DOMINION NUCLEAR CONNECTICUT, INC.
MILLSTONE POWER STATION UNIT 2
RESPONSE TO SECOND REQUEST FOR ADDITIONAL INFORMATION FOR
ALTERNATIVE REQUEST RR-04-16 FOR THE USE OF ENCODED PHASED
ARRAY ULTRASONIC EXAMINATION TECHNIQUES (PAUT) IN LIEU OF
RADIOGRAPHY (TAC NO. MF2520)

RESPONSE TO SECOND REQUEST FOR ADDITIONAL INFORMATION FOR
ALTERNATIVE REQUEST RR-04-16
PROPOSED ALTERNATIVE TO ASME SECTION III

**MILLSTONE POWER STATION UNIT 2
DOMINION NUCLEAR CONNECTICUT, INC.**

Figure 1
Weld 4 – Flaw 3, Incomplete Penetration

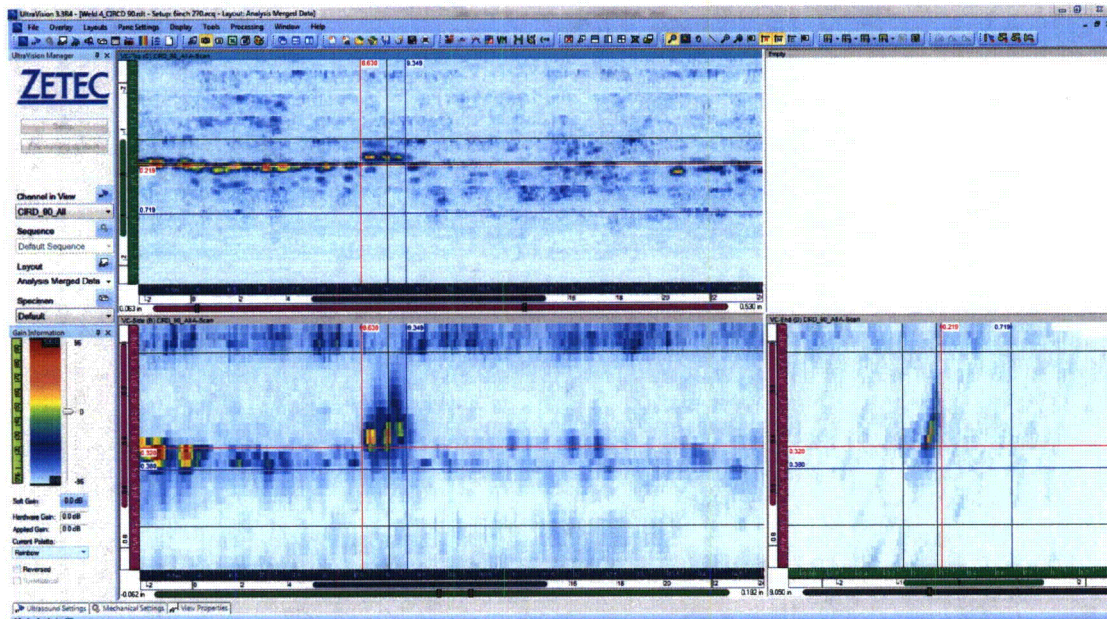
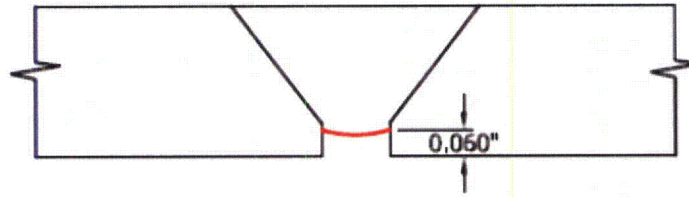
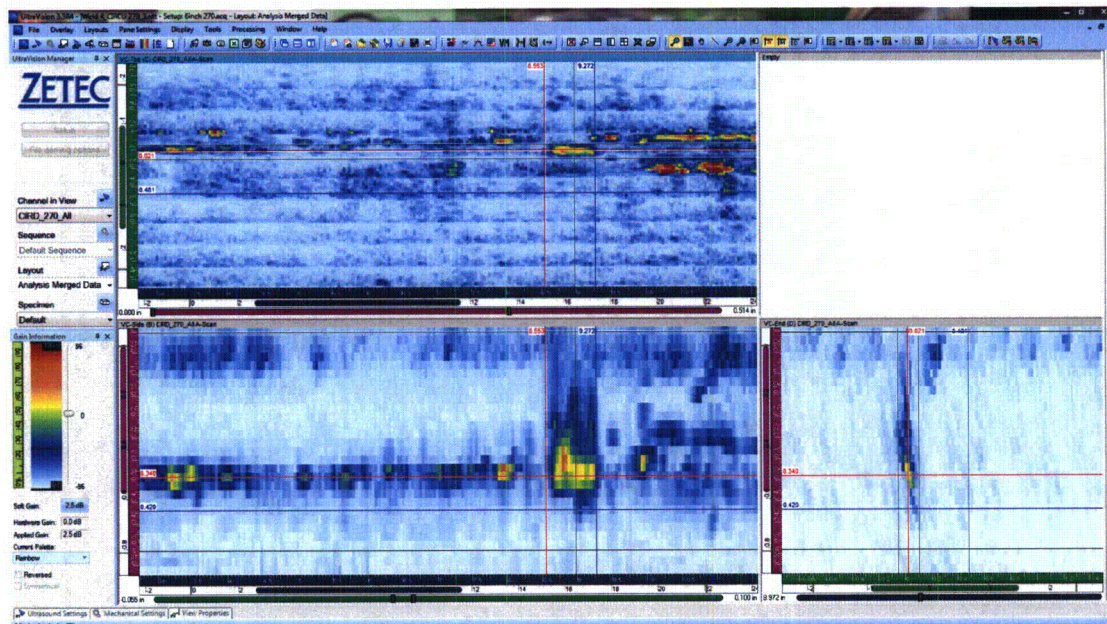
Provide examples of successful ultrasonic detection of planar flaws in the 0.28 inch thick test blocks.

The following Figures 1 through 5 provide examples of the ultrasonic data representing successful detections and characterizations of typical fabrication flaws from the Dominion procedure qualification data. These figures provide examples of lack of fusion defects, lack of penetration defects, and cracks, which were implanted into the 6 inch diameter, 0.28 inch thick welded mockups. These mockups represent the weld configurations and welding processes to be used for the replacement welds. The flaw map for each of these examples is included in the applicable figures. The planar flaws identified in Figures 2, 3, and 4 were not detected with the radiographic examination performed.
